# Monthly Specification Update

***Intel® Server Boards S5500HV***

***Intel® Server System SR1670HV***

**October, 2009**

### 1. One power connector pin-outs definition in TPS is not correct

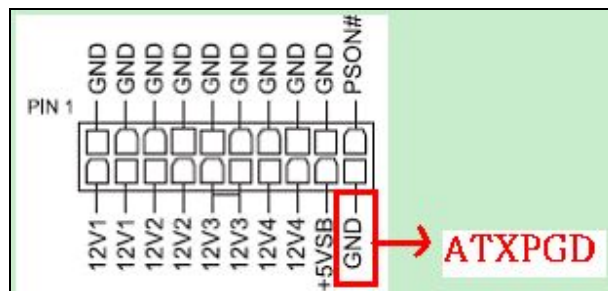
One power connector pin-outs definition is not correct,

Please refer below revision

This correction has been implemented in TPS revision 1.1.
